# Access Compliance Report

## Public Rights-of-Way

### (Curb Ramps)

Intersection ID: 42581	Main Street: GERALDINE_POWE_DR	Cross Street: RISING_OAK_DR	Location:	E
ADA ID: B9F0A9BF3B30	Ramp Type: BlendTrans1	Initial Pass/Fail: Pass	Overall Compliance: No	Severity Score: 20

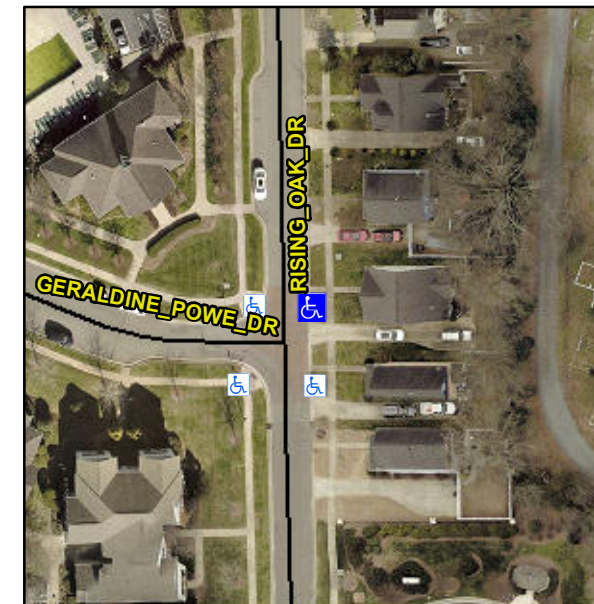
**XWALK PAVERS**

**Not Found, R305.2, R302.7, R302.7.2, R304.5.4**

Compliance	Description	Data	Compliance	Description	Data
N/A	Ramp Length (in)	93.5	Yes	BlendTrans Slope (%)	4.6
Yes	Ramp Width (in)	49.5	Yes	BlendTrans XSlope (%)	1.5
N/A	Flare Type LT	Sloped	N/A	Flare Type RT	Sloped
N/A	Flare Slope LT (%)	4.3	N/A	Flare Slope RT (%)	8.3
N/A	Flare Traversable LT?	No	N/A	Flare Traversable RT?	No
Yes	Landing Length (in)	48.0	Yes	DWS Provided?	Yes
Yes	Landing Width (in)	49.0	Yes	DWS Contrast?	Yes
Yes	Landing Slope (%)	0.6	Yes	DWS Length (in)	24.0
Yes	Landing X Slope (%)	2.2	Yes	DWS Full Width?	Yes
N/A	Landing Curb? (Y/N)	No	No	DWS Offset (in)	4.0
N/A	Shared Landing?	No			
No	Gutter Ponding?	Yes	No	Gutter Slope (%)	7.8
No	Gutter Lip Ht (in)	1.0	Yes	Gutter X Slope (%)	2.8
N/A	Painted X Walk1?	No	N/A	Painted X Walk2?	N/A
	X Walk 1 Direction	To W		X Walk 2 Direction	N/A
	X Walk 1 Width (in)	N/A		X Walk 2 Width (in)	N/A
	X Walk 1 Slope (%)	1.2		X Walk 2 Slope (%)	N/A
	X Walk 1 X Slope (%)	3.0		X Walk 2 X Slope (%)	N/A

N/A	Ramp inside XWalk1?	N/A	N/A	Ramp inside XWalk2?	N/A
	Road Slope (%)	3.0		Clear Space?	Yes
	Road X Slope (%)	1.2	N/A	Clear Space to XWalk (in)	N/A
Yes	Any Obstructions?	No	Yes	Storm Grate/Utility Hazard?	No
	Obstruction Type			Storm Grate/Utility Type	
		N/A			N/A
			Yes	Surface Condition? (G/P)	Good
			No	Curb Slope (%)	14.0

**Remove & Replace Curb Ramp With Two New Directional Ramps or Equivalent. Remove & Replace Gutter.**
